**STAFF REPORT:** 07/12/2023 MEETING  
**APPLICATION NUMBER:** 23-8443  
**ADDRESS:** 2495 W. BOSTON  
**HISTORIC DISTRICT:** BOSTON-EDISON HISTORIC DISTRICT  
**APPLICANT:** MARK CLEMENTS  
**PROPERTY OWNER:** ROBERT DESNER  
**DATE OF PROVISIONALLY COMPLETE APPLICATION:** 06/20/2023  
**DATE OF STAFF SITE VISIT:** 06/27/2023

**SCOPE:** ALTER FRONT PORCH

Figure 3: Annotated rendering of the brick porch additions provided by the applicant. Proposed new construction is outlined by the red rectangle.

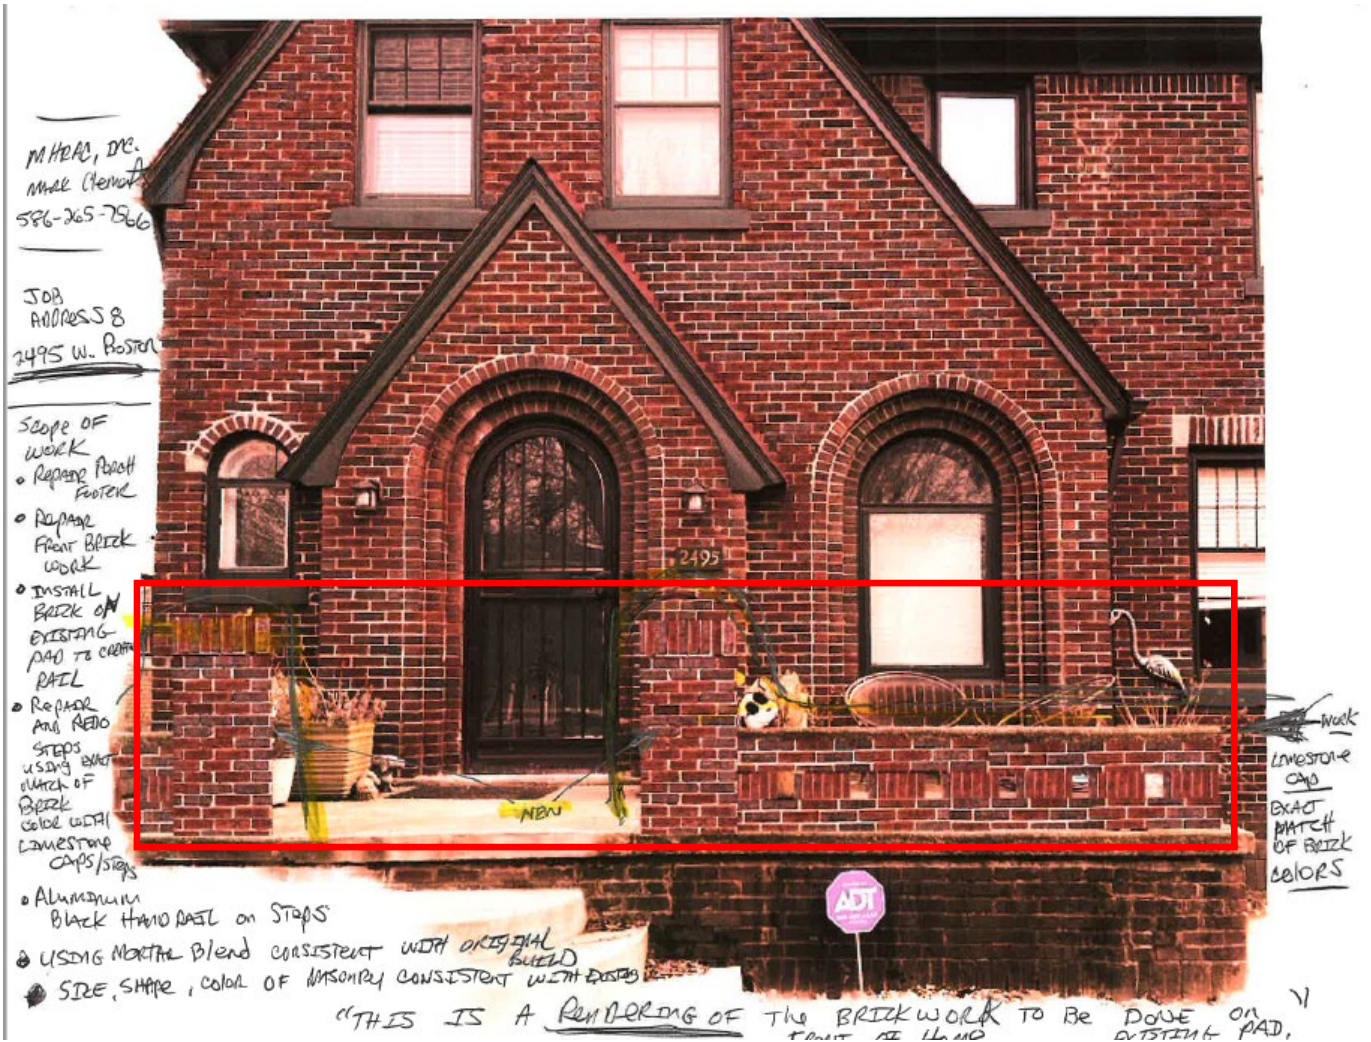
- It is staff's opinion that the proposed project constitutes an appropriate alteration to the subject property. The proposed rectangular limestone steps and brick knee wall on the porch deck (granted a COA by HDC on June 20, 2023) closely resemble the original configuration of the porch as observed in the 1974 photograph above. The brick piers and proposed black metal handrails appear to be of a material and scale that are appropriate for the architectural character of the building and will not have a detrimental visual effect on the dwelling or any of its character defining features.
- HDC staff requested dimensioned drawings of the final proposed porch improvements for HDC review that have not been received at the time of this report. These drawings are required to confirm the scale and materials of the project will be appropriate.

1. Plan and elevation drawings with dimensions and materials callouts that include all aspects of the proposed project (piers, knee walls, stairs and railings) be provided for HDC staff approval before work commences.
